OPTIONAL SERVICE BULLETIN

NO. OSB-42-046/2

Retrofit of the TAE 125-02-99 engine

TAE125-02-99 Preassembled Engine Retrofit Installation

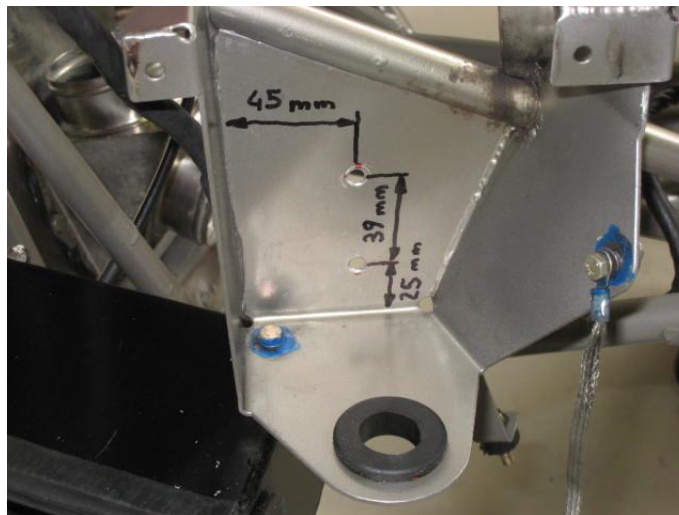
Modifications on firewall (on RH engine only):

Remove screws and flange for fuel lines, disconnect fuel lines inside of the nacelle and remove 45° Fittings.
Install straight fittings and nuts (P/N AN832-6 and AN6289-6), connect fuel lines on new fittings and install flange for fuel lines onto firewall. Use sealer PR812/Kit25 between flange and fire wall. Tighten the fittings acc. the values given in the AMM, Chapter 20.

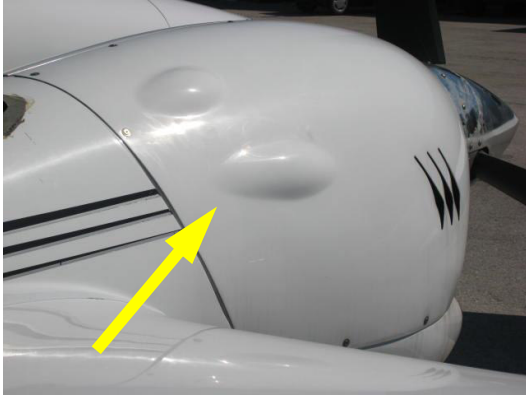
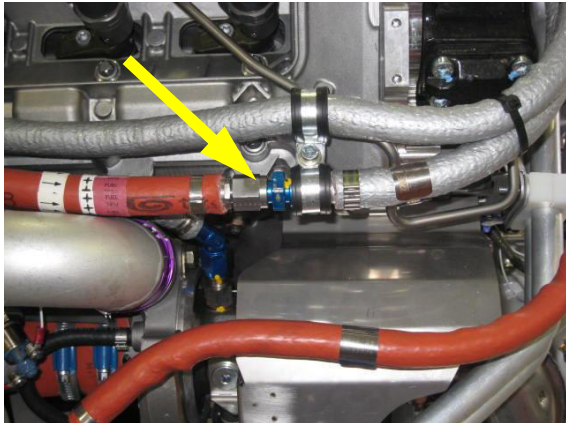
86	Install the engine cowlings. (refer to AMM Section 71-00) Note: If the old Cowling-design was installed, a new cowling set is necessary.  old cowling design  new cowling design Note: When new cowlings are installed, it may be necessary to adjust trim and Camloc positions to fit the individual airplane. Adjust the exhaust pipe after installation of the bottom cowling and tighten the three nuts (torque acc. the values given in the AMM).
87	Install the access panels on the nacelle.
88	Perform items 1 to 88 for RH side.
89	Perform weighing (refer to AMM Section 08-10.)
90	Refuel airplane, remove cowling, fill and bleed fuel system. Note: Tighten and lock wire the fitting in the fuel line. 
91	Perform engine ground test (refer to the Operators Manual of Continental Aerospace Technologies GmbH for the TAE 125-02 engine and AMM, Chapter 71-00, 3. (Engine Test-General).
92	Perform a check flight (refer to AMM, Chapter 05-20-00)

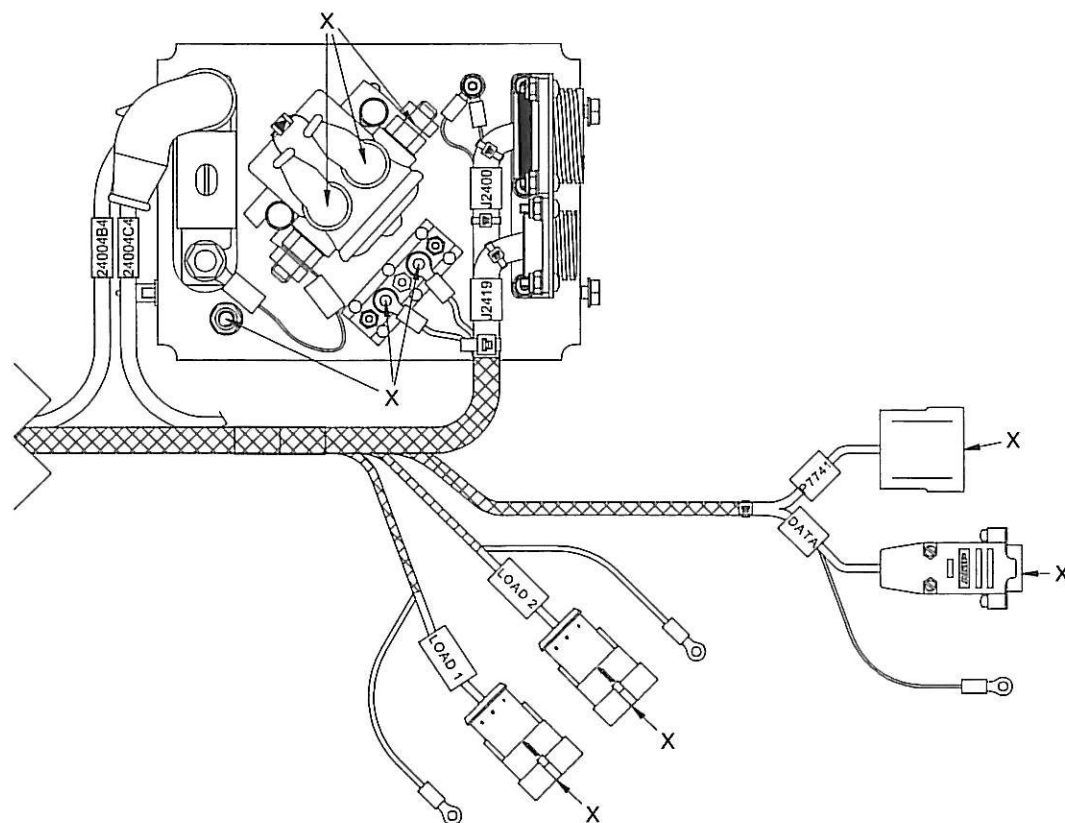
Step 1:
Disconnect the Thielert Engine Harness at the positions marked X.

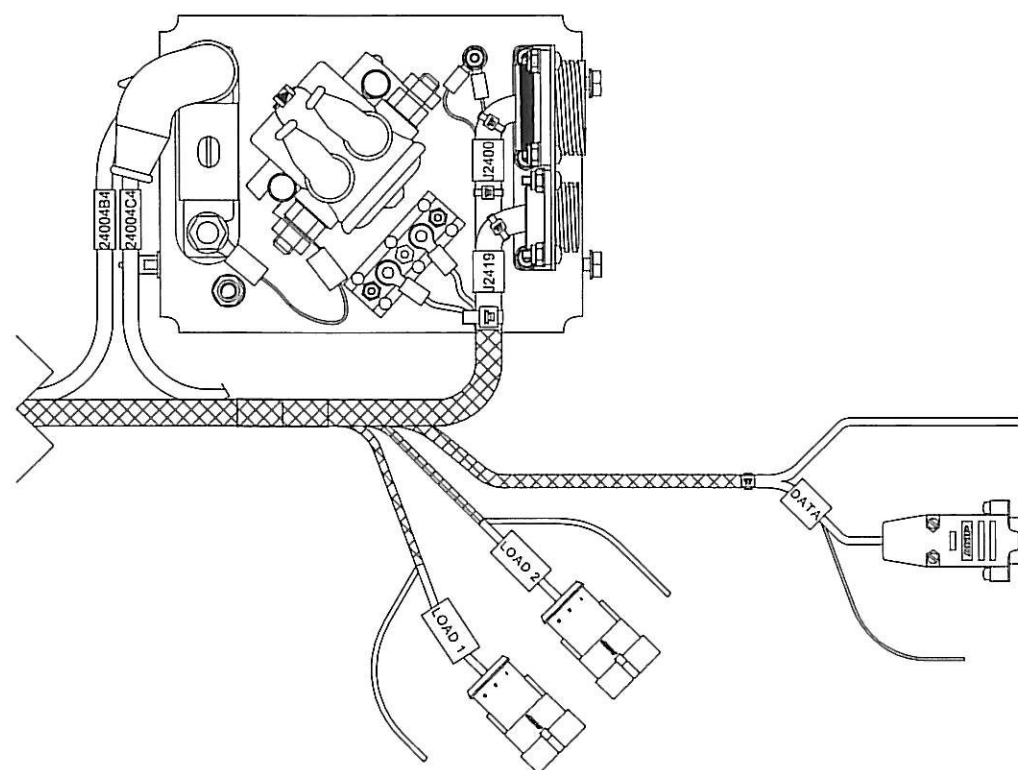
Step 3:
Extract the pins of connector P7741 and cut them off.

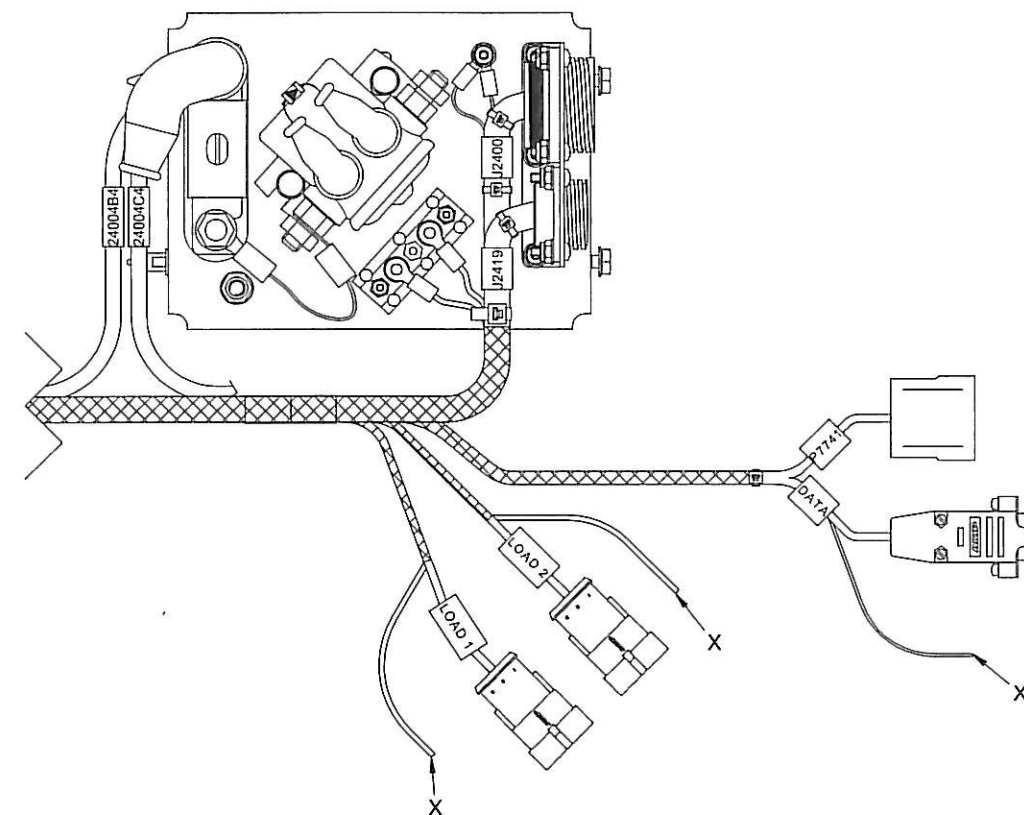
Step 2:
Cut-off the ring terminals of the LOAD1, LOAD2 and DATA connector shields at the positions marked X.

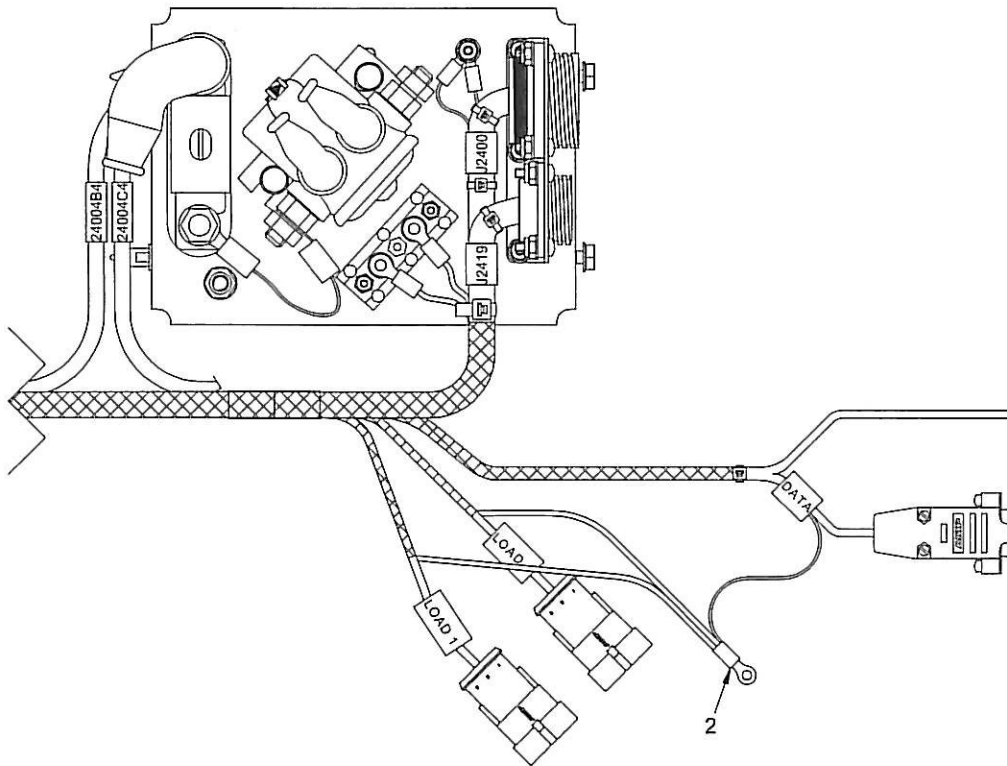
Step 4:
Install the 3 shield wires into one ring terminal, Position 2.

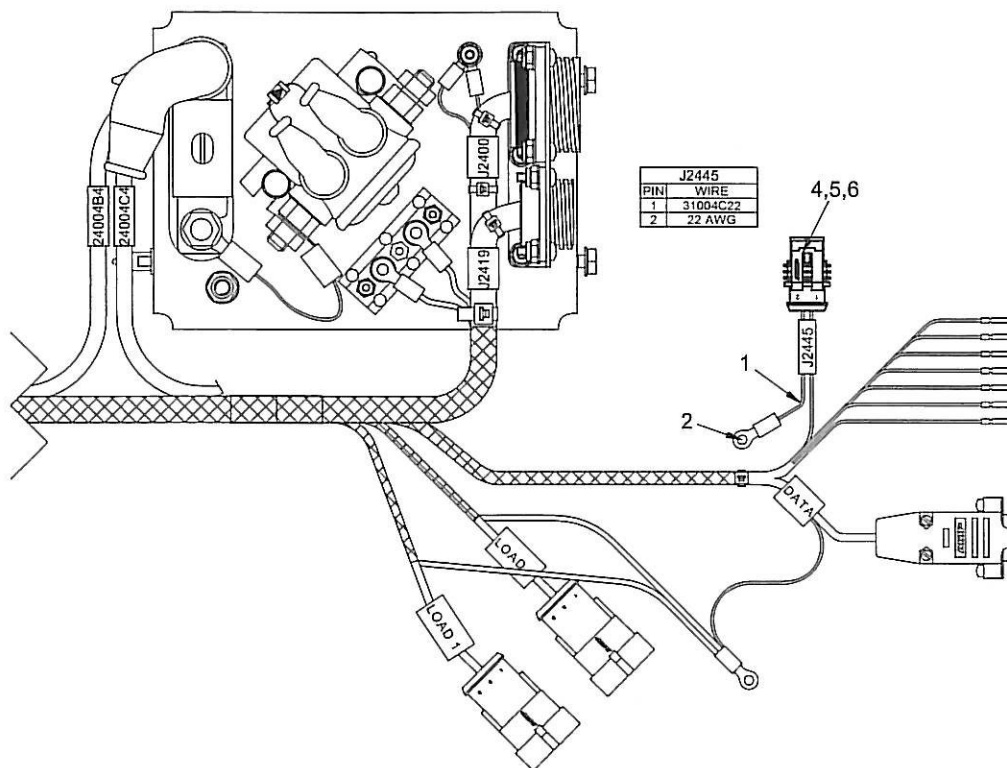
Step 6:
Install connector and label, Positions 4, 5, 6 onto wire 31004C22, Pin 1.
Install 150mm #22 AWG into Pin 2 and a ring terminal Pos. 2 on the other end.

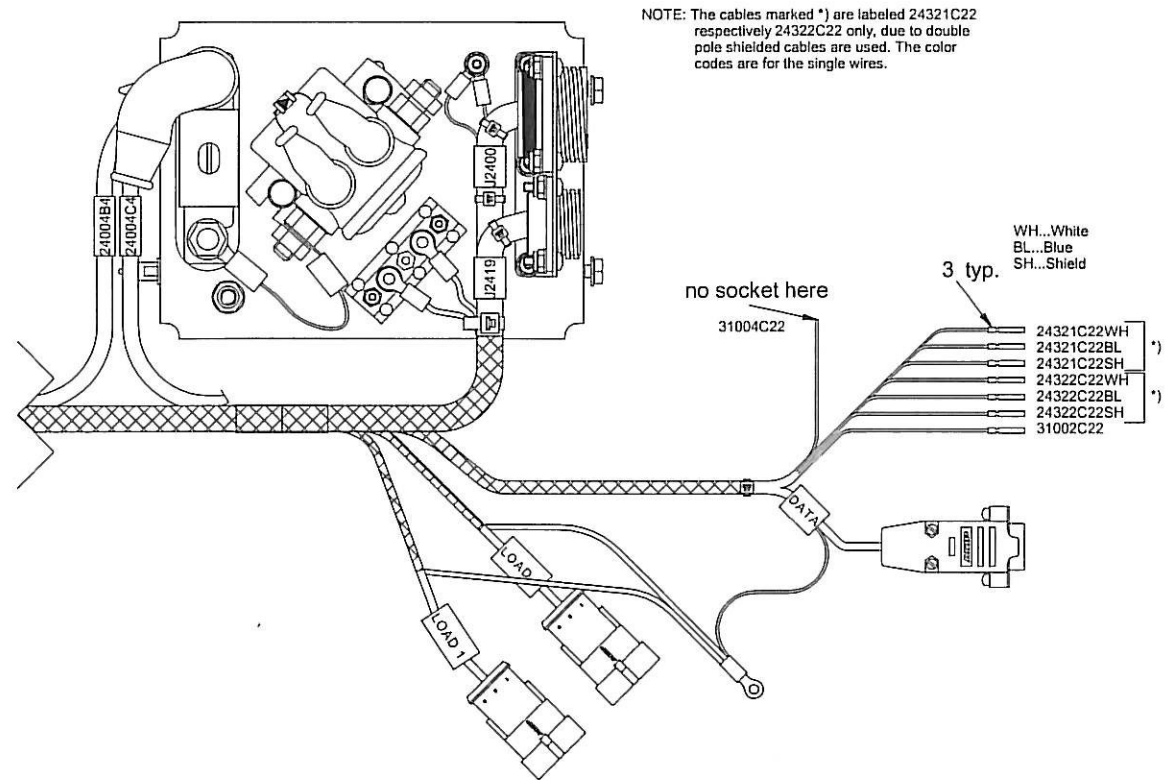
Step 5:
Crimp sockets, Position 3 onto the wires shown below.

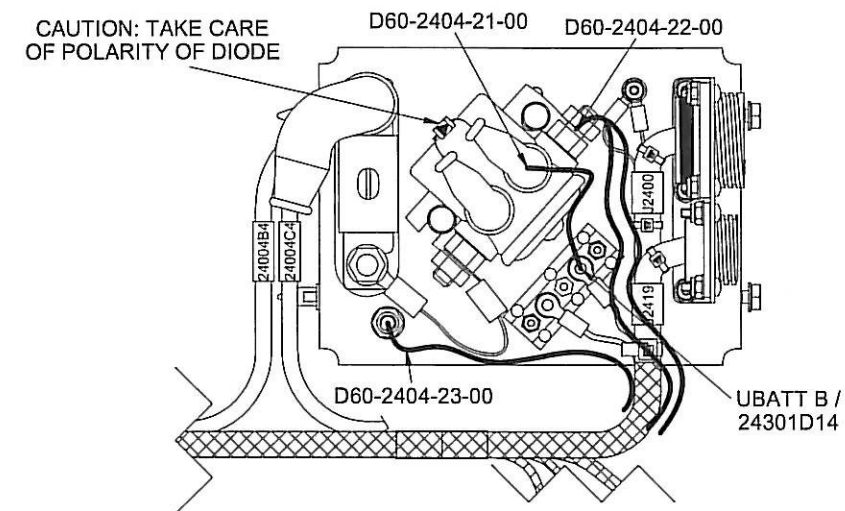
Step 7:
Install Wire, Glow Rel + (D60-2404-21-00-SB); Wire, Glow PWR (D60-2404-22-00-SB) and Wire, Glow GND (D60-2404-23-00-SB) as shown below.

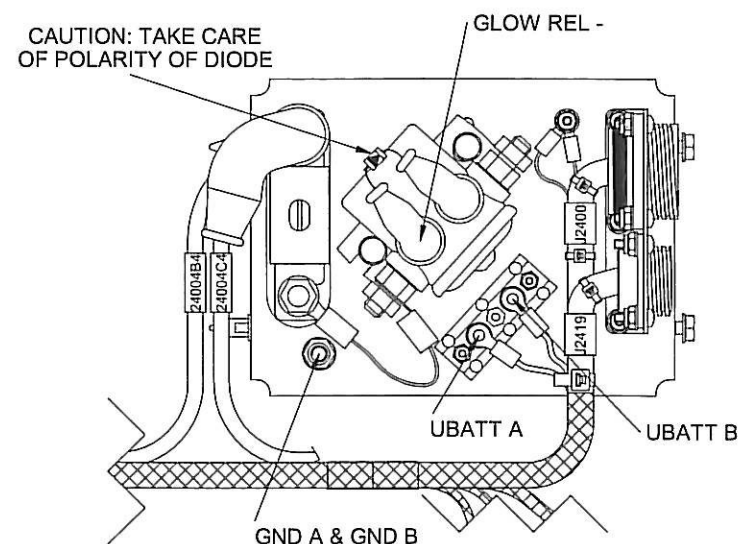
Step 7:
Connect Adapter Harness, Central Connector (D60-2404-20-00-SB) as shown below.

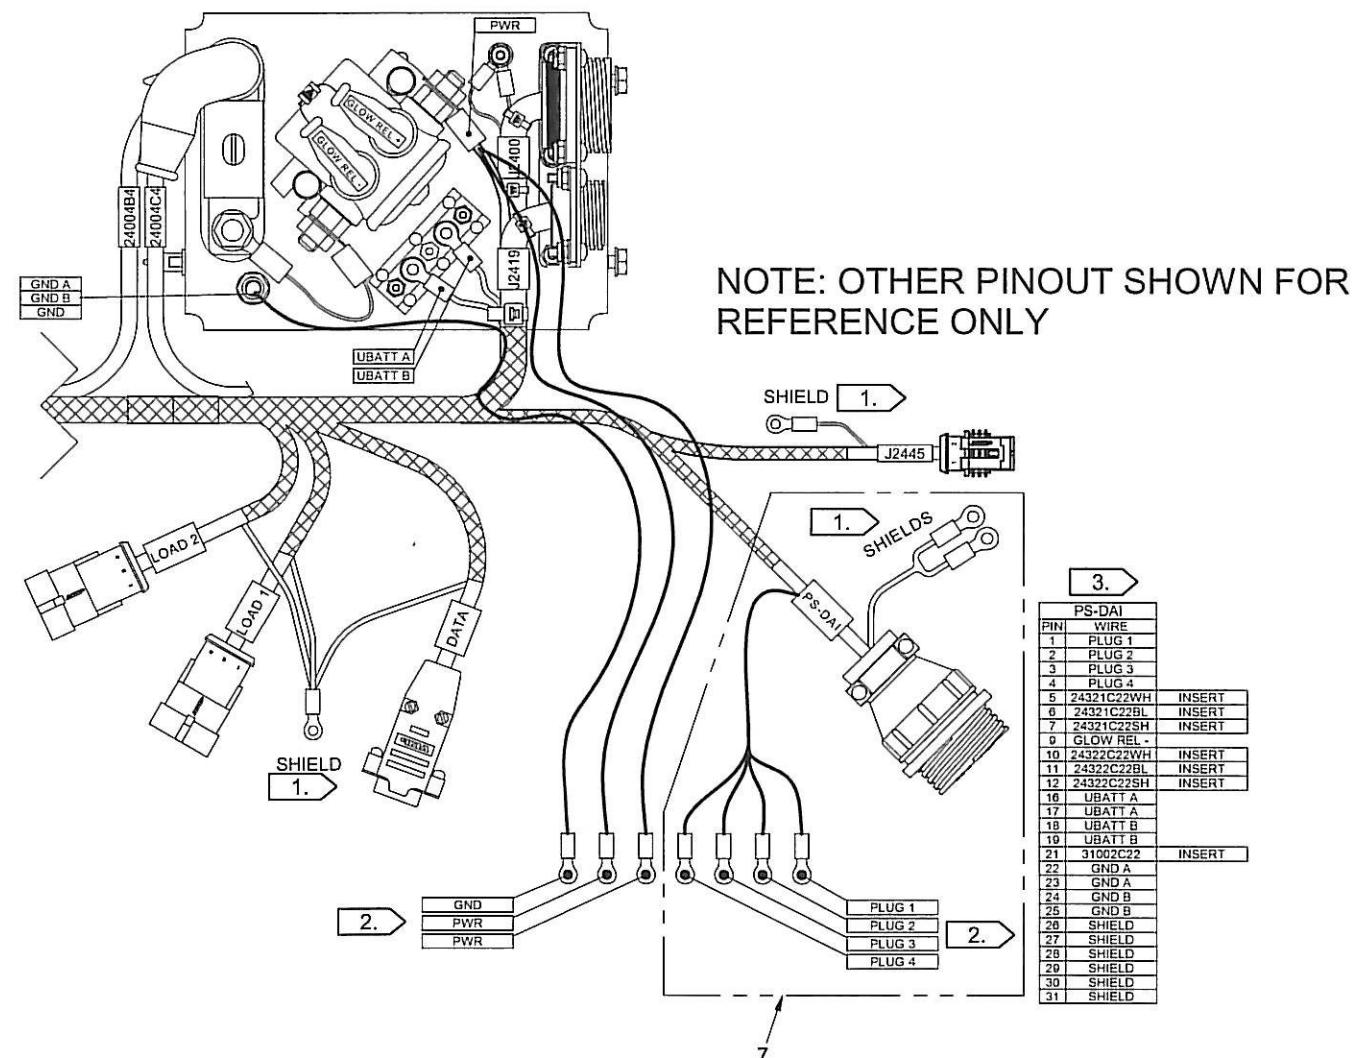
Step 8:
Insert the sockets, prepared in Step 5, into the new central connector (PS-DAI) as shown below.

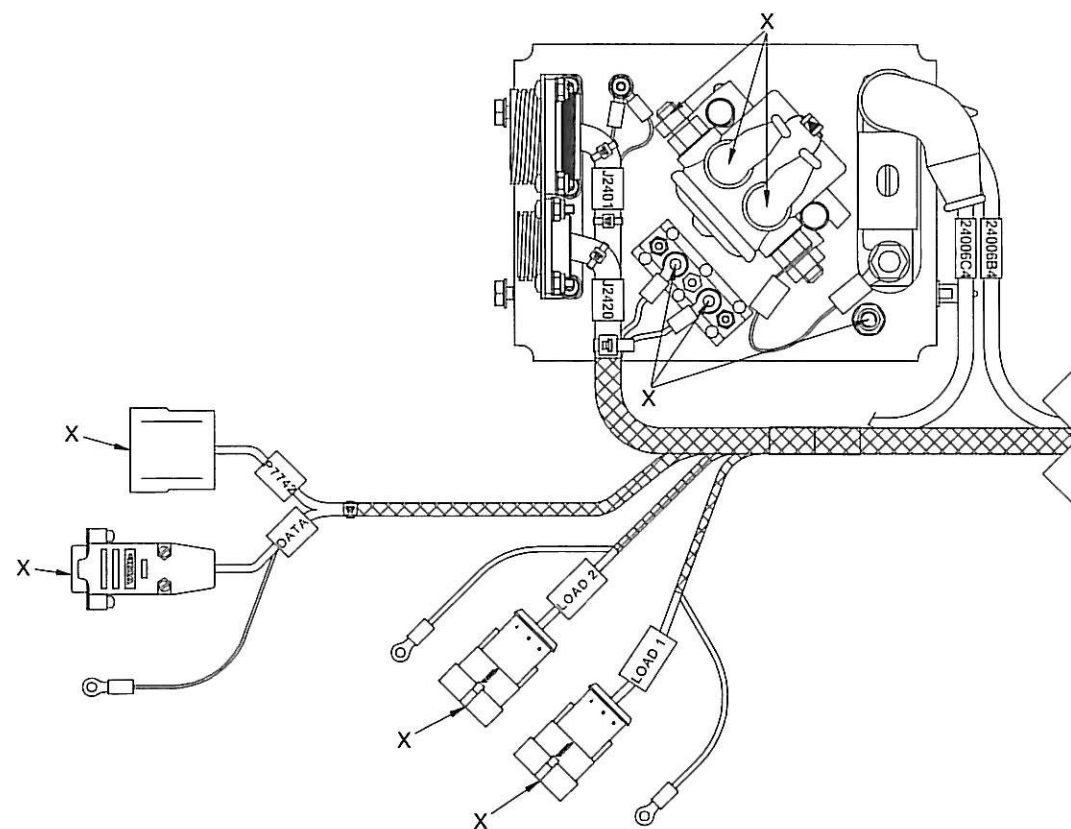
Step 1:
Disconnet the Thielert Engine Harness at the positions marked X.

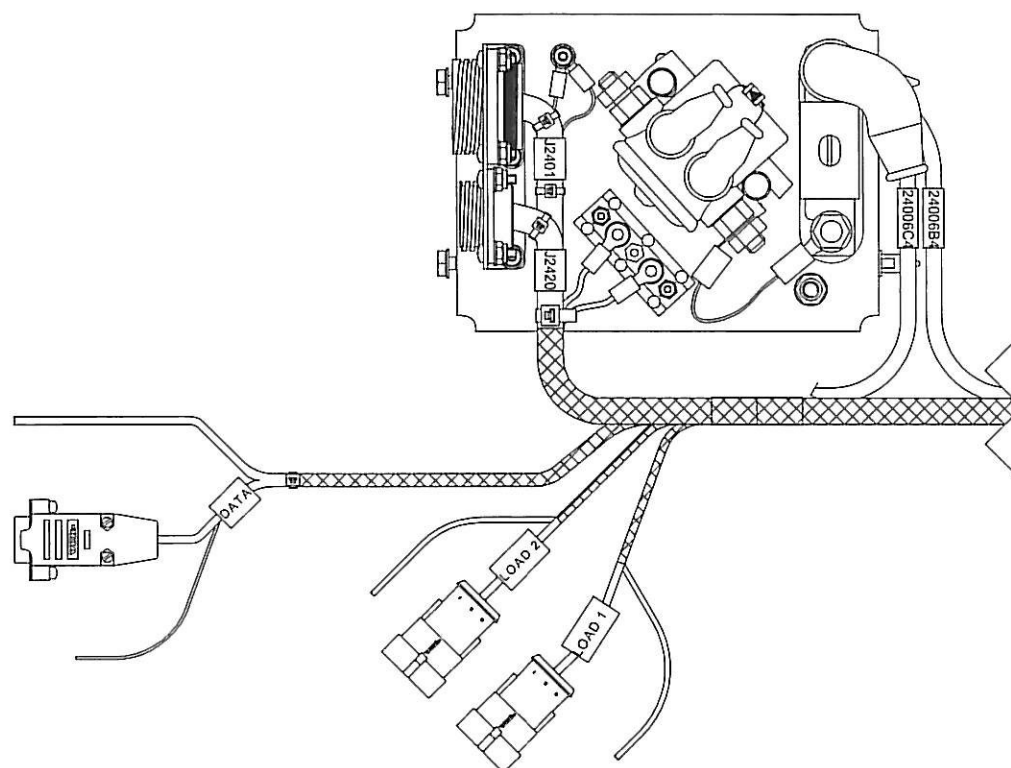
Step 3:
Extract the pins of connector P7742 and cut them off.

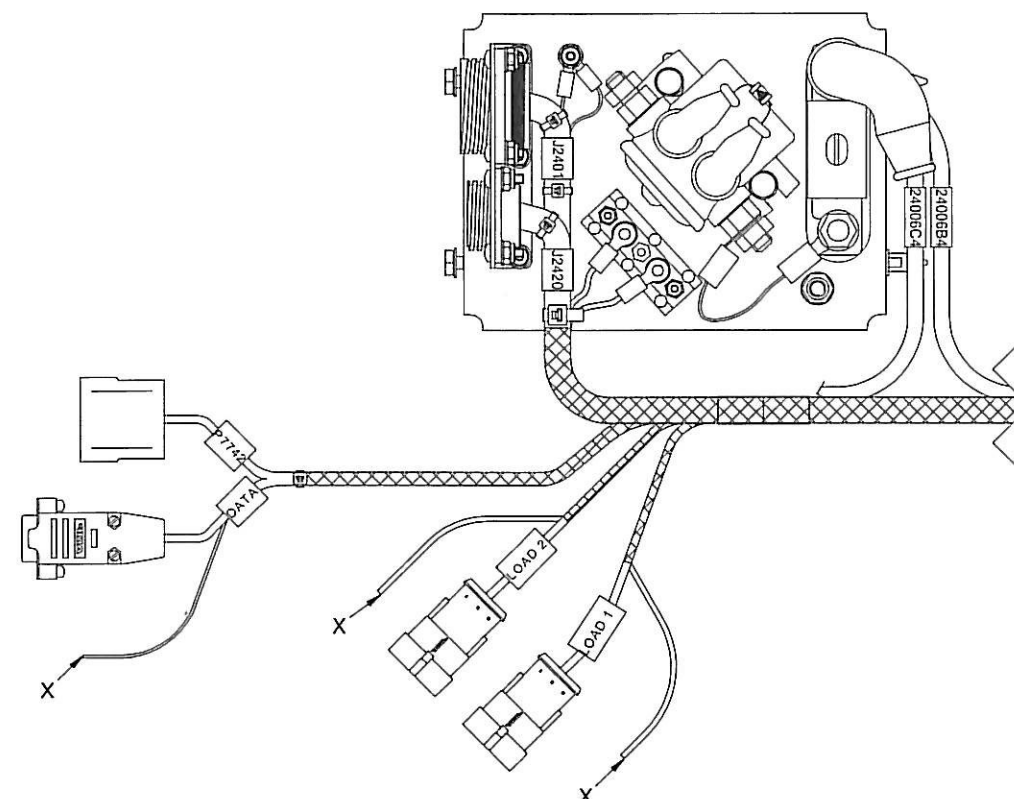
Step 2:
Cut-off the ring terminals of the LOAD1, LOAD2 and DATA connector shields at the positions marked X.
